SUBJ: **Clarifications to the Specifications and Responses to Vendor's Questions**

BID ITEM: **Bid Item 19-185 Construction of New Fire Station #3 and #20 for Augusta, GA – Fire Department**

ADDENDUM 4

SCALE: AS NOTED
A-802

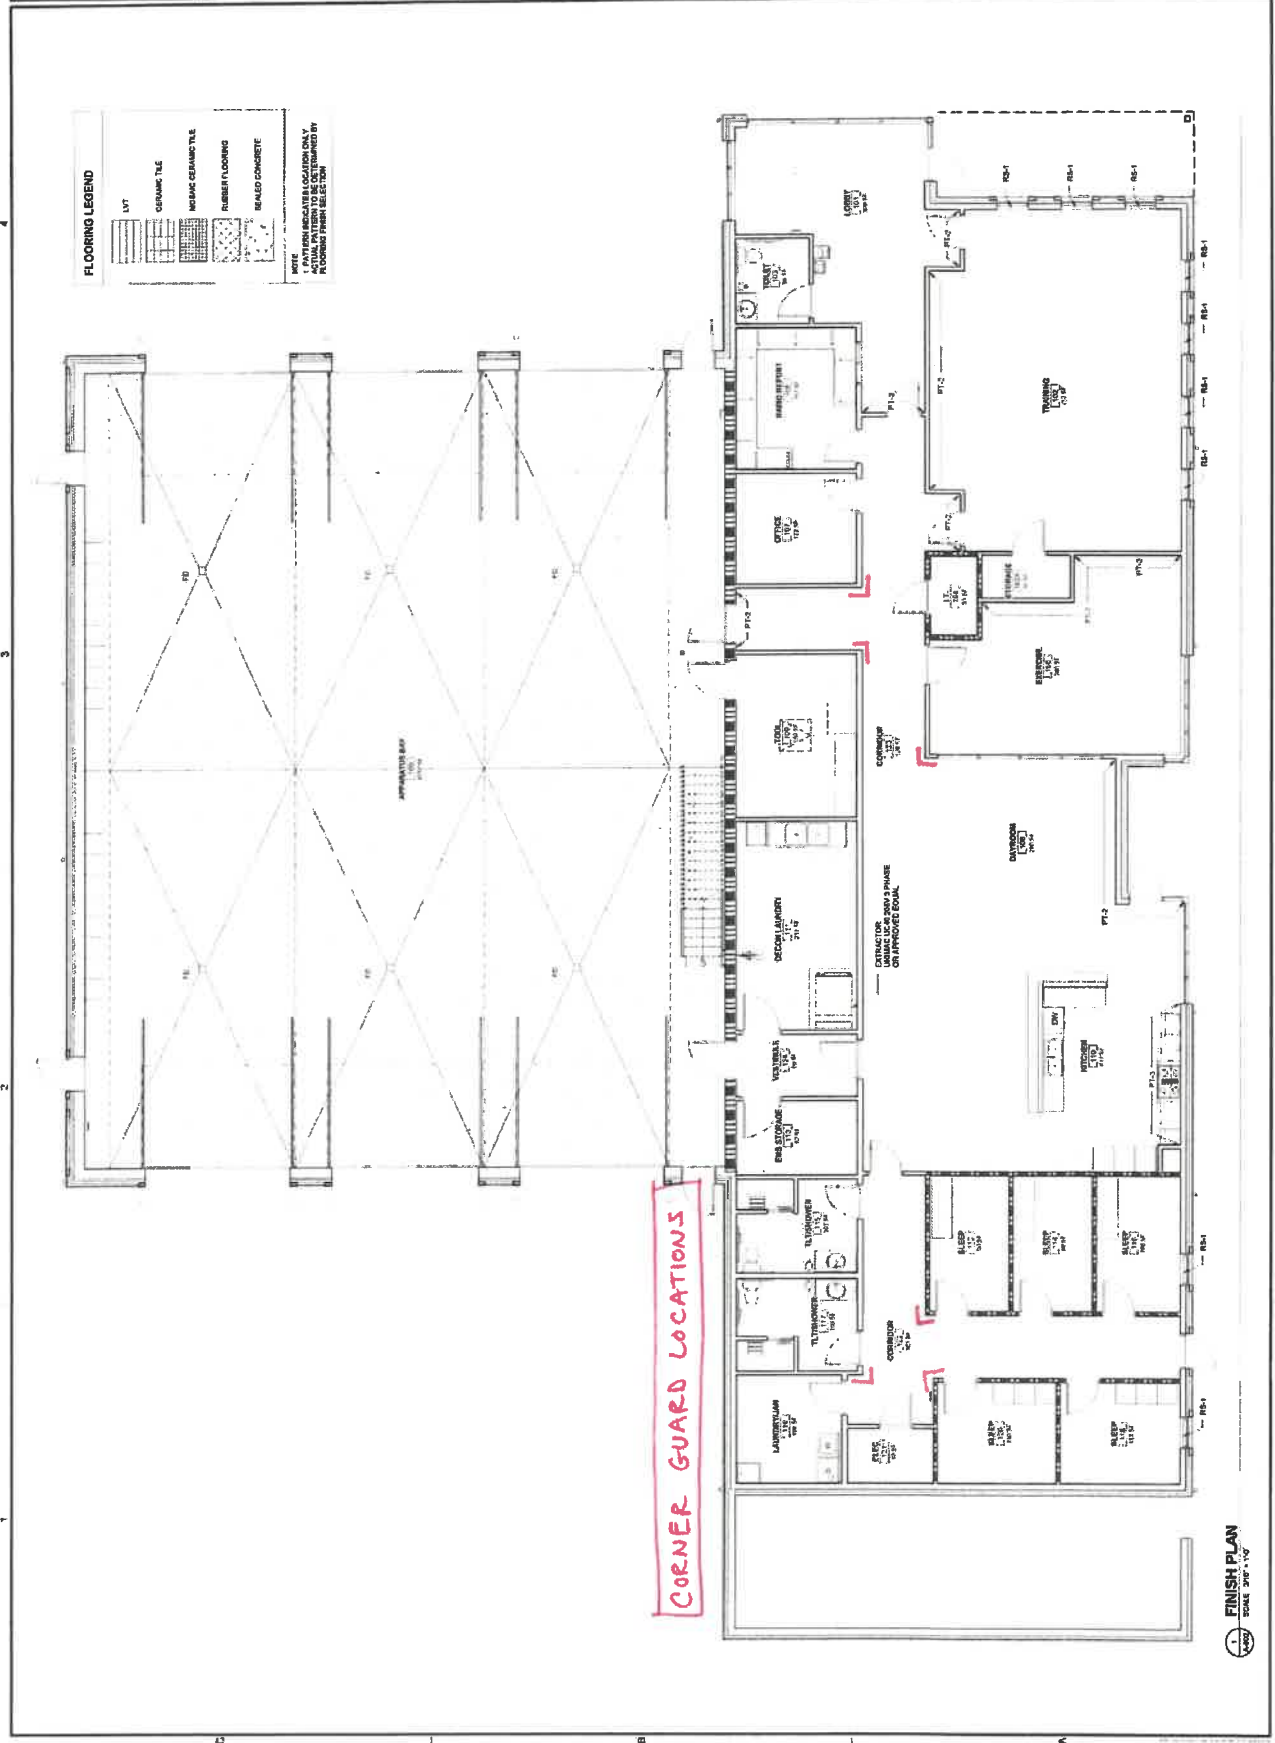
8. QUESTION: Addendum Number 2, Question 22 states the Mezzanine Framing on 2/S-201 is attached to this addendum. This detail is not attached to this addendum. Can you please provide this detail?

RESPONSE: Detail 2/S-201 was included as part of the original bid documents. The floor finish for mezzanine will be a sealed concrete.

DRAWING NO. **S-202** REV. **1**

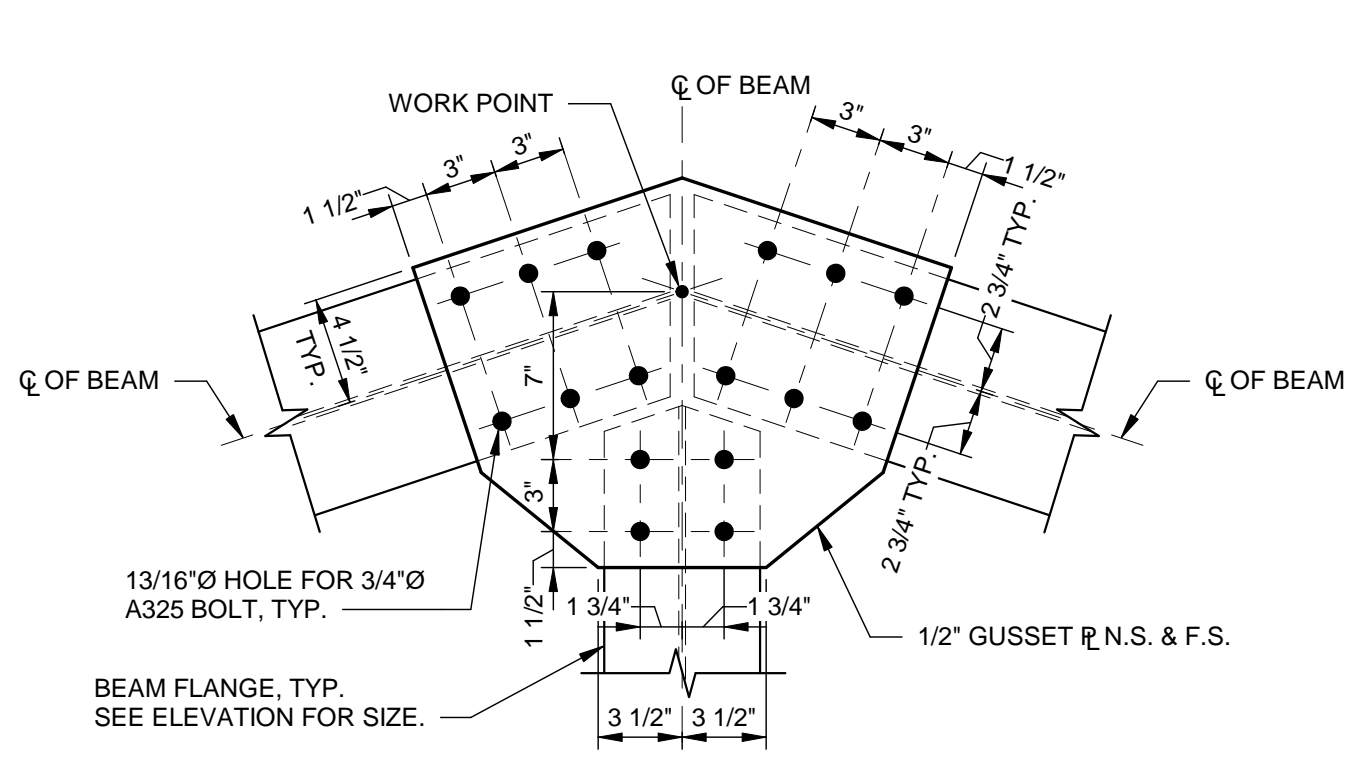
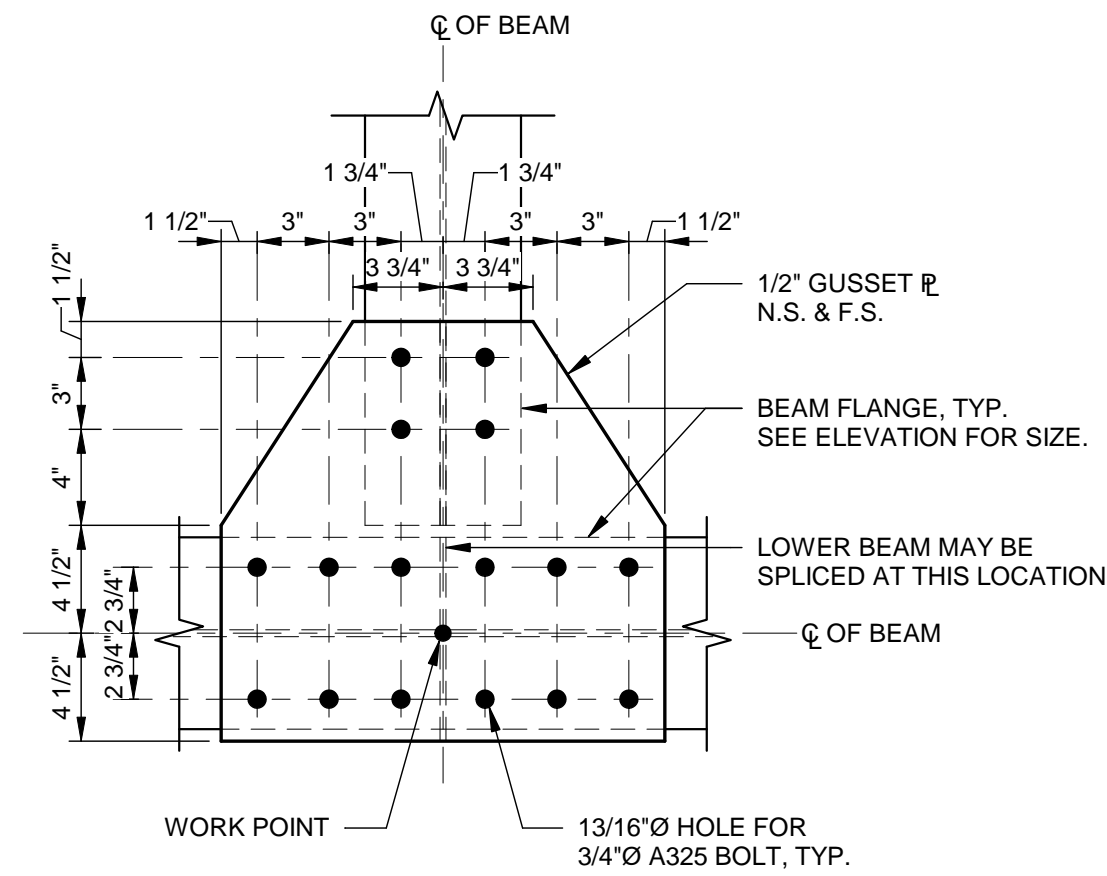
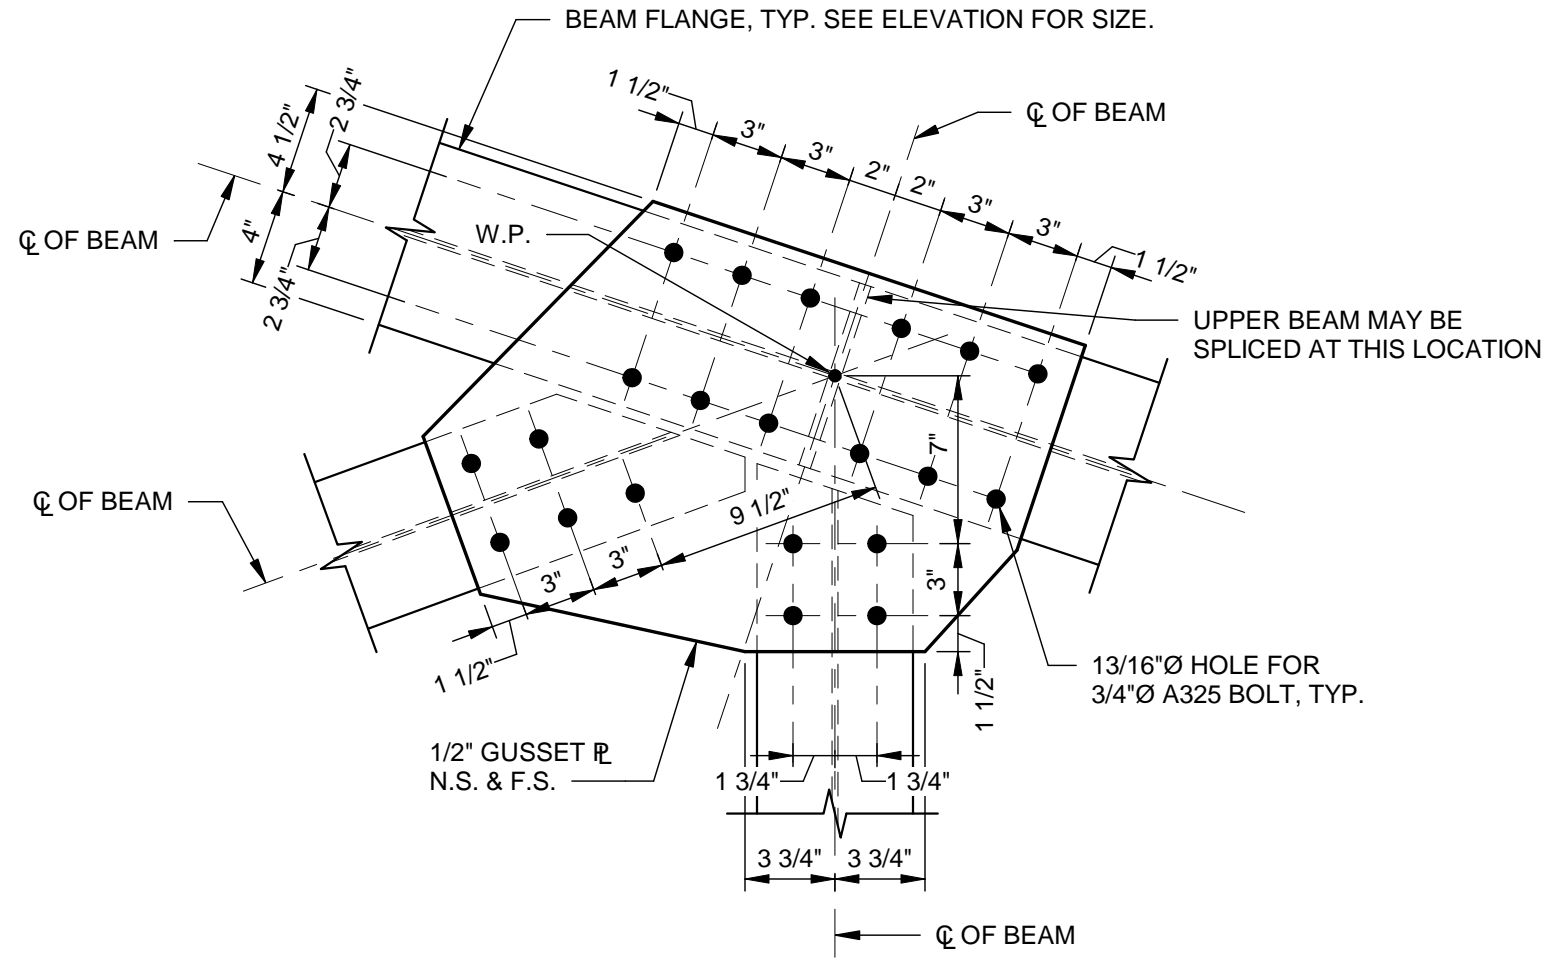
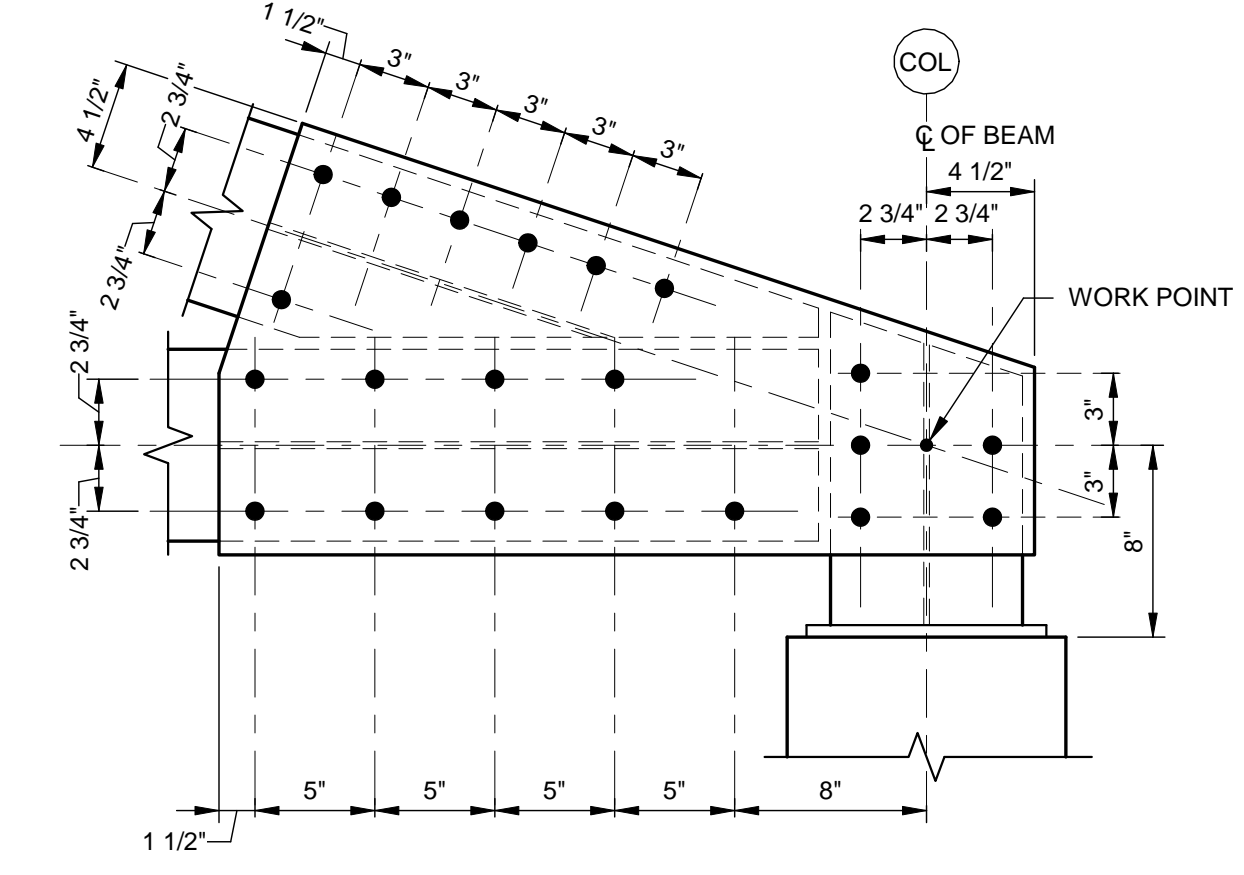
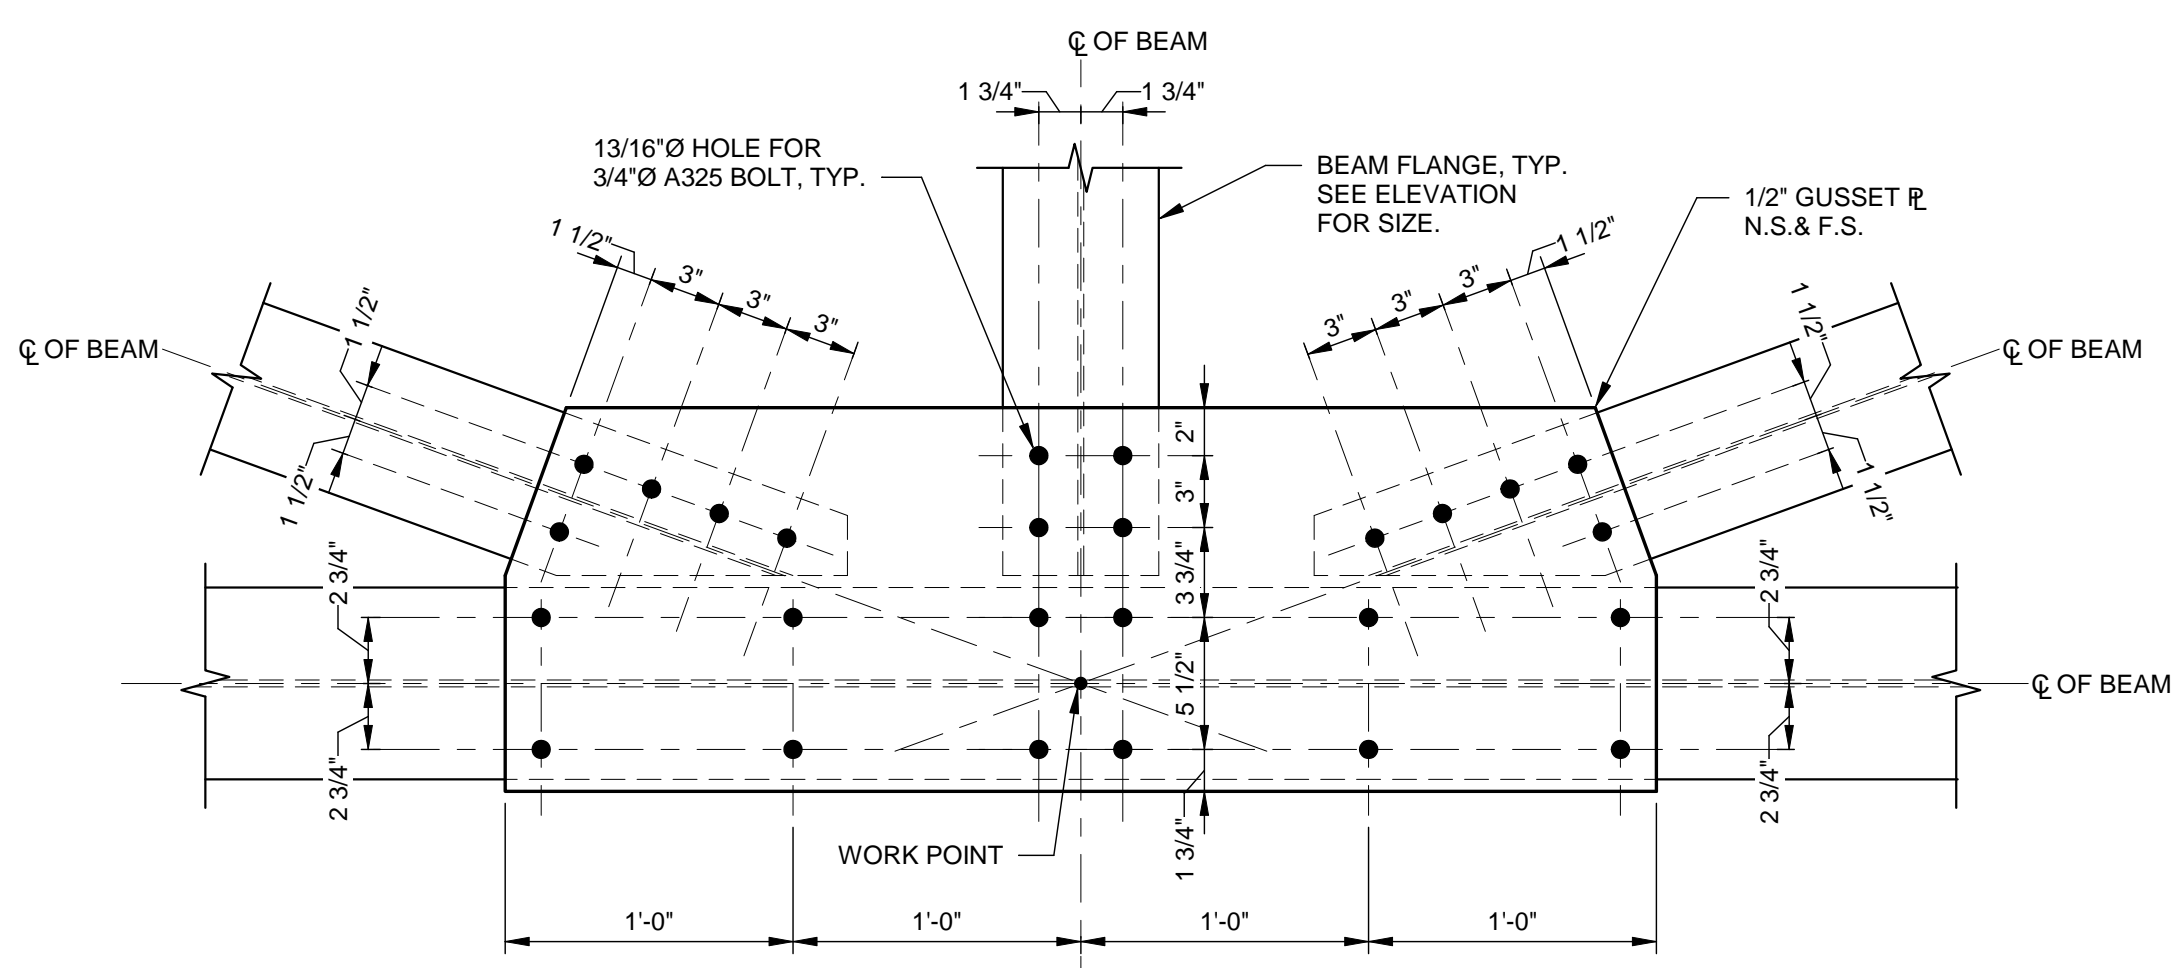
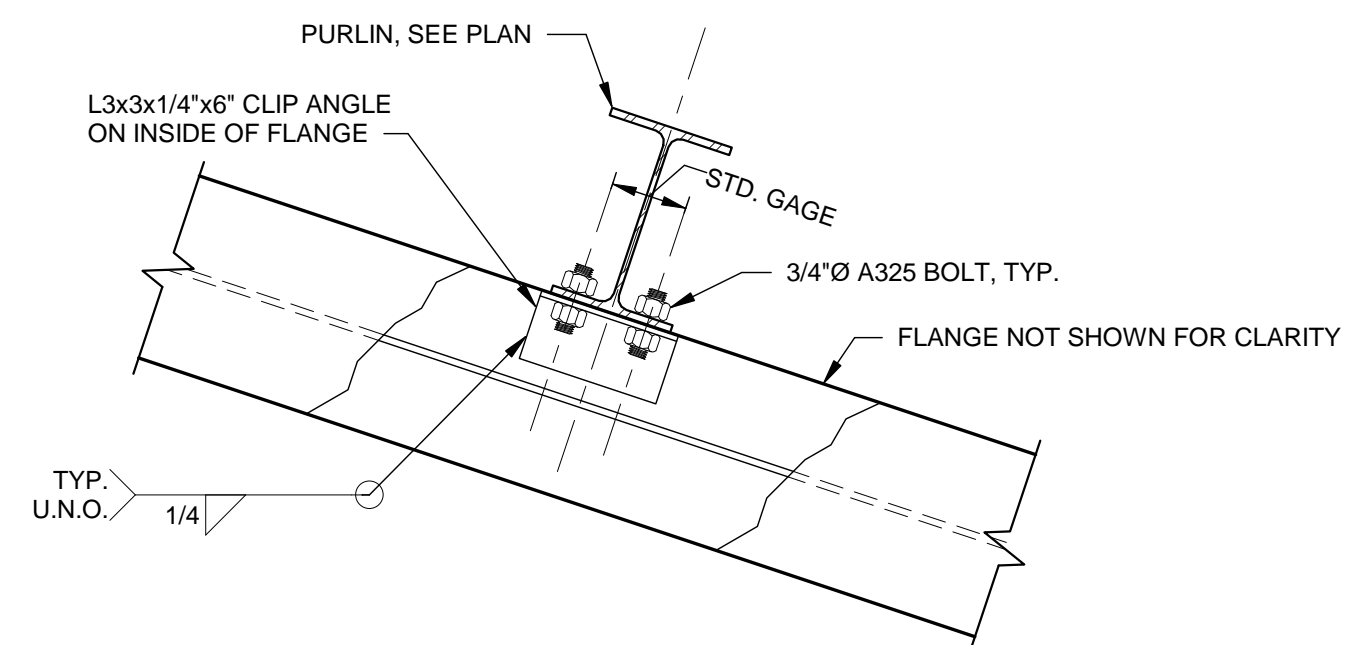
5. QUESTION: The truss elevations on S-201 do not show enough information to accurately price the steel. A note says "beam flange, typ. see elevation for size," but the elevations do not show the size. Please provide more information on the steel used for the trusses.

RESPONSE: Please see revised drawing S-202_R1 for steel sizes attached to this Addendum 4.
